Model: Reveil-MF1	Date: 25-May-16	No.: RM291001b
-------------------	-----------------	----------------

Subject: Firmware Release Note: Main		Prepared by: Y. Miyamoto	
From: 1st Tech Service Sect., MFP/Printer Tech Service Dept.			
Classification:	<input type="checkbox"/> Troubleshooting	<input type="checkbox"/> Part information	<input type="checkbox"/> Action required
	<input type="checkbox"/> Mechanical	<input type="checkbox"/> Electrical	<input type="checkbox"/> Service manual revision
	<input type="checkbox"/> Paper path	<input type="checkbox"/> Transmit/receive	<input type="checkbox"/> Retrofit information
	<input type="checkbox"/> Product Safety	<input checked="" type="checkbox"/> Other (Firmware)	<input checked="" type="checkbox"/> Tier 2

Model: Rev-P1/MF1		Date: 29-Nov-16	No.: RM291003
Subject: New "Dot coverage" function		Prepared by: Y. Miyamoto	
From: 1nd Tech Service Sect., MFP/Printer Tech Service Dept.			
Classification:	<input type="checkbox"/> Troubleshooting	<input type="checkbox"/> Part information	<input type="checkbox"/> Action required
	<input type="checkbox"/> Mechanical	<input type="checkbox"/> Electrical	<input type="checkbox"/> Service manual revision
	<i

Scanner Unit

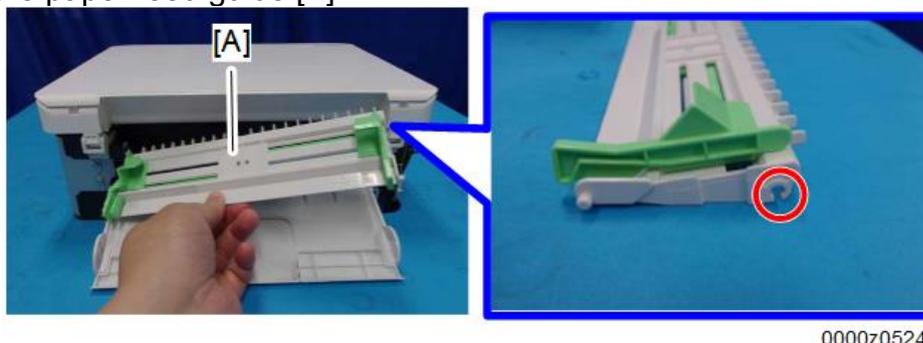
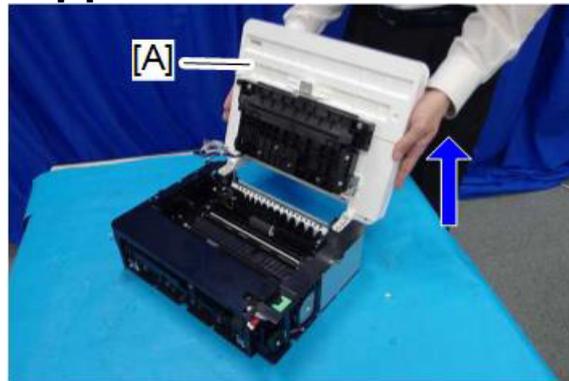
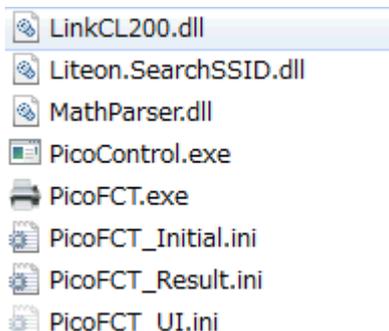
The procedure for replacing to a new scanner unit was revised. Before replacement, you have to obtain the PC software “48L3_ABC_Maintain” with the link below to conduct the CIS calibration.

- After installing a new scanner unit, the software adjustment is required since this machine has no scanner home position.
- Using the software in the link above, the machine can detect the home position with a certain algorithm.
- If this adjustment is not fully conducted, SC1001 may occur in a case that a home position of a new scanner unit is quite different from the old one.
- The CE Tool for this model cannot conduct the home position adjustment.

1. Remove the AIO.
2. Remove the bottom cover.
3. Remove the main board.
4. Release the guides of the paper feed tray [A].

5. Remove the paper feed guide [A].

- To remove the paper feed guide [A], release the right linkage first.

6. Remove the rear cover from the right-hand side [A].

7. Open the scanner unit [A] and remove the guide rail [B]. (x1)

8. Remove the scanner unit [A].

9. Remove the laser unit from the scanner unit [A]. (x4)

· After installing to a new scanner unit, following adjustment with the PC software “48L3_ABC_Maintain” is required.
